# Enterprise Recycling & Disposal Facility

Angelo's Aggregate Materials, Ltd.

Pending Modification Permit Nos. 0177892-005-SO/MM and  
0177982-006-SC/MM

## Response to Requests for Additional Information

FIGURE  
3-17

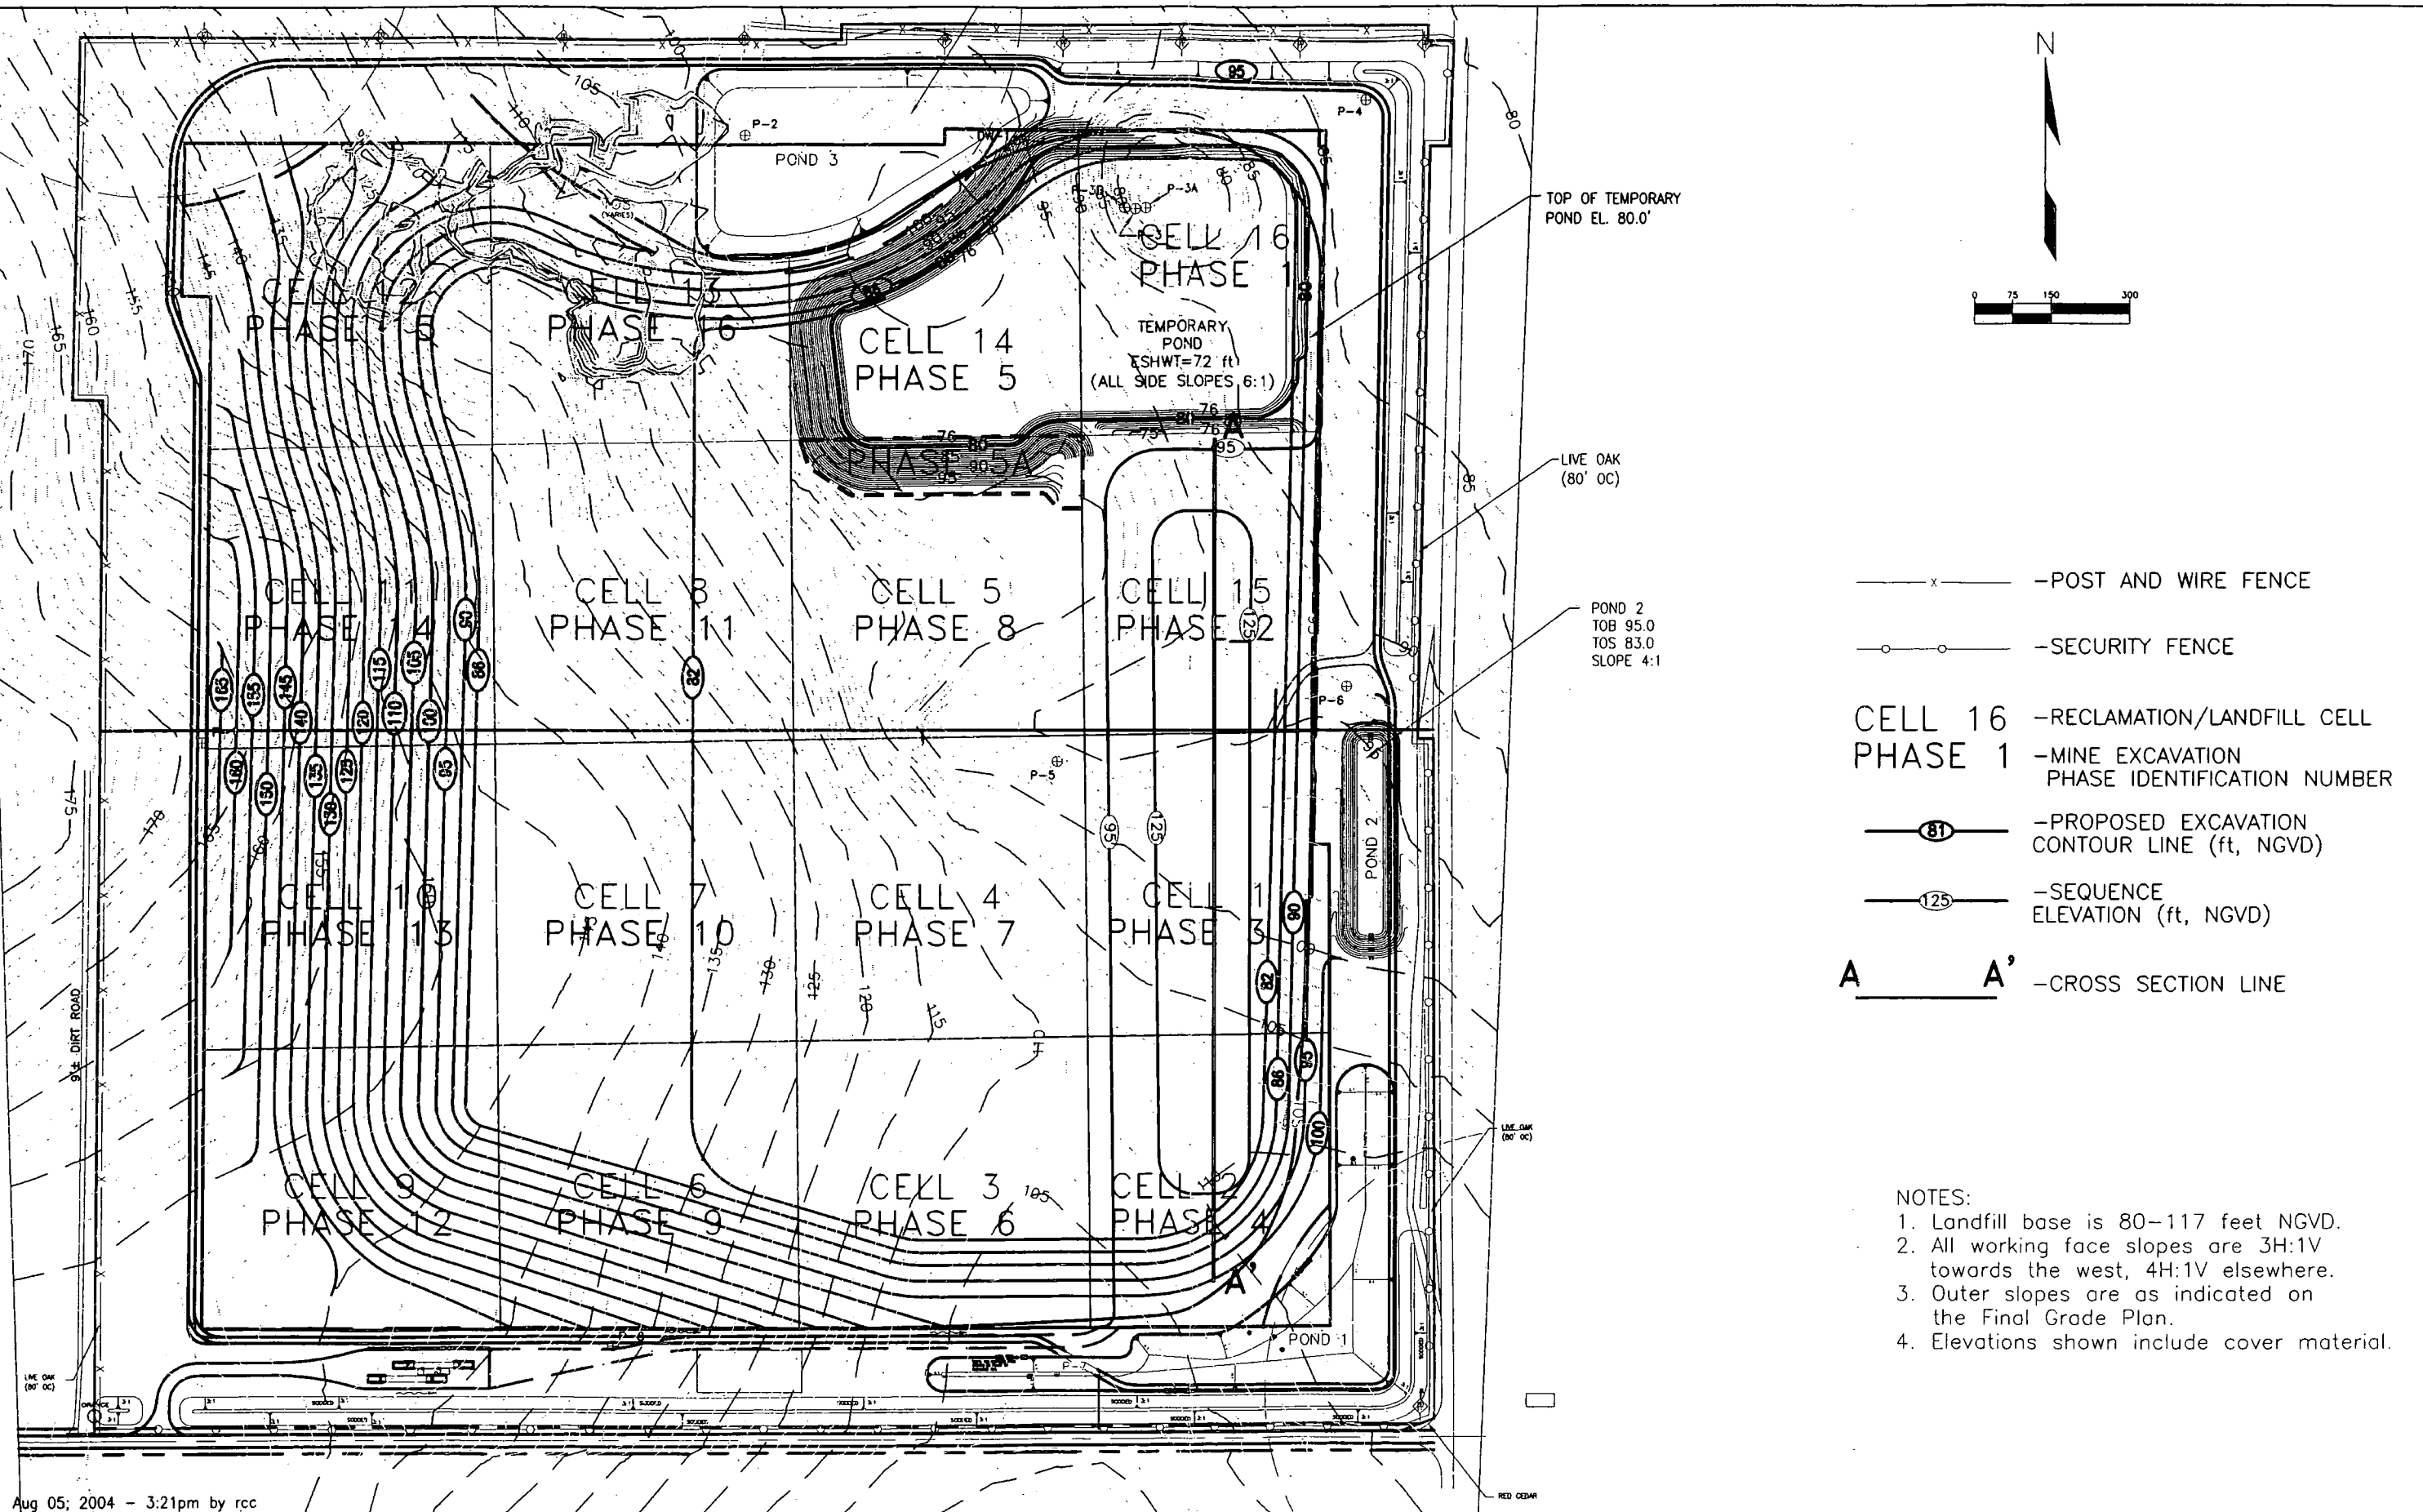
25. Figure 3-17. Please show the base grades on this drawing. Please note that it is not necessary to show the final elevations for sequence 1, alternatively the final elevations can be shown as very light contour lines.

26. Figure 3-17 is inconsistent with Figure C-2 in regards to the bottom-grading plan for Cell 5. What is the expected water elevation in the temporary pond?

27. Figures 3-17 and 3-18, note 2 is inconsistent with Section 8.1 of the Operations Plan and Section 3.8 of the Engineering Report which state that the working slopes will not exceed 3(H):1(V) prior to 125 feet NGVD. Please correct the appropriate document(s) accordingly.

**Response:** The temporary pond grading shown on Figure 3-17 indicates the required grading from the current topography in the area of Cells 5 and 14. The top of bank elevation for the temporary pond is 80 feet, NGVD.

**Response:** Note 2 on Figure 3-17 and 3-18 has been revised to reflect the text in the Engineering Report and Operations Plan.

FIGURE  
3-26

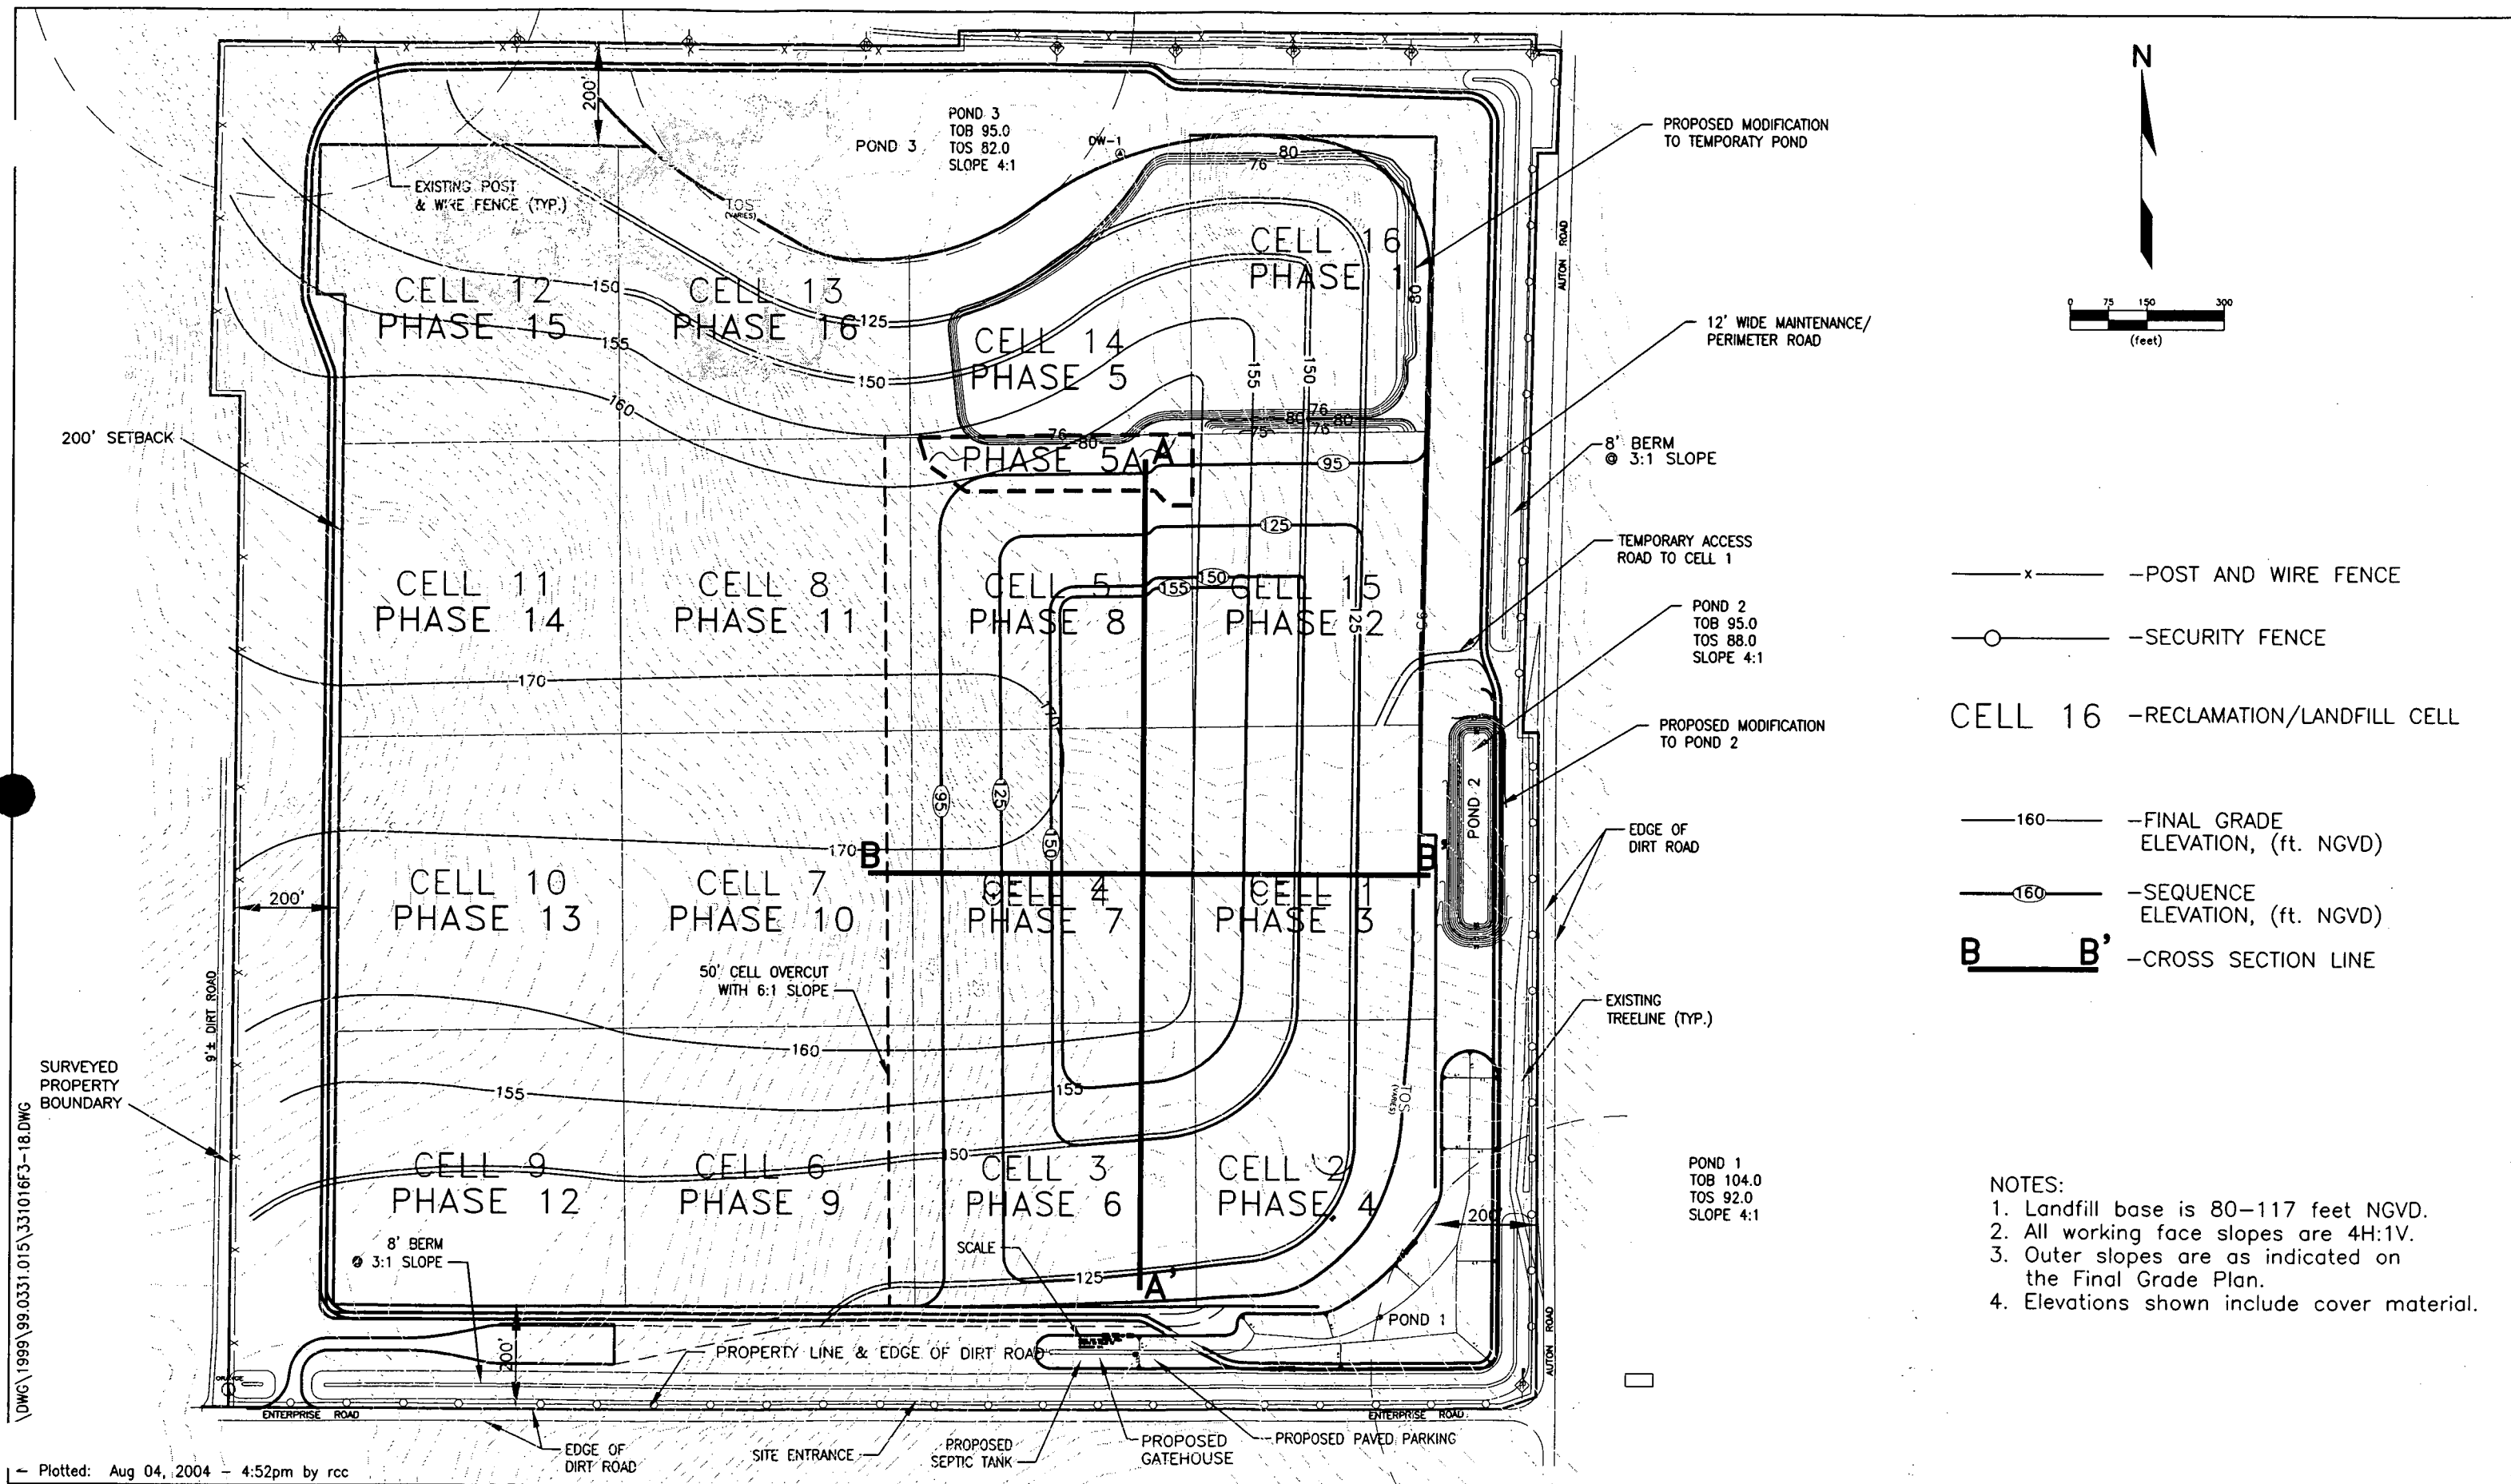
25. Figure 3-17 indicates that all the cells to be filled in sequences 1 and 2 will be at a base elevation of 82 feet NGVD. However, the cross-sections shown in Figures 3-26, 3-27 and 3-28 indicate that some cells will have a base elevation of 80 feet NGVD. Please revise the appropriate drawing accordingly.
